**Subject:** Re: District of North Vancouver - Single Family Regulations letter to consultants and contractors

Re: Proposed Changes to Single Family Regulations – Retaining Walls and Accessory Buildings and Structures

INPUT: Proposed Changes to Single Family Regulations Retaining Walls and Accessory Buildings and Structures

# Comments on changes to Single Family Regulations

*Figure 1: 45 degree angle on left / 35 degree angle on right*

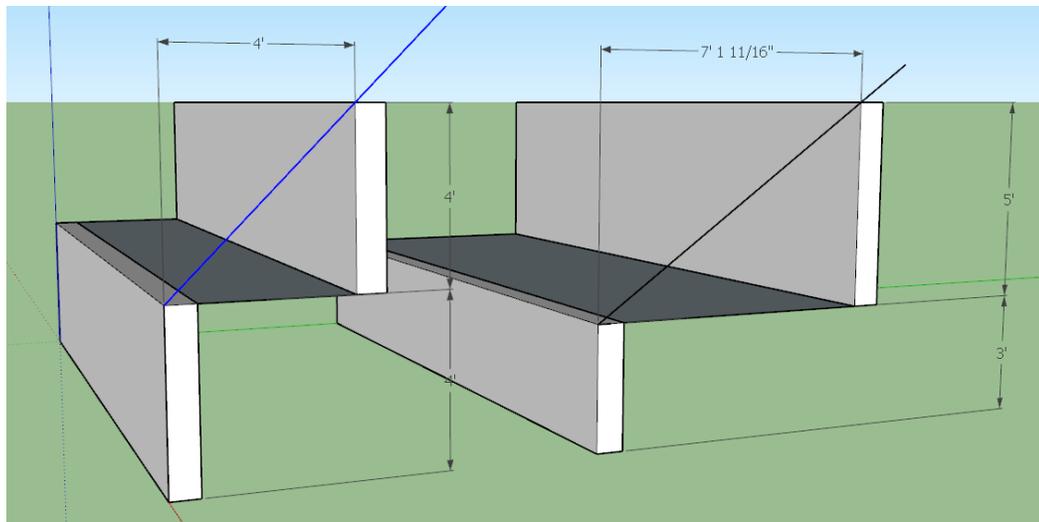
To ensure we can retain 8’ of grading, instead of only setting the 2<sup>nd</sup> retaining wall 4’ away from the property line such as shown on the left, we would now have to setback the 2<sup>nd</sup> retaining wall over 7’ away from the Property Line, an increase of 56%. An additional

consideration with this; the space between the 2 retaining walls is typically difficult to access and unusable for yard space, thus increase unusable yard space without providing any additional benefits.

Our recommendation is to the leave the bylaw as is.
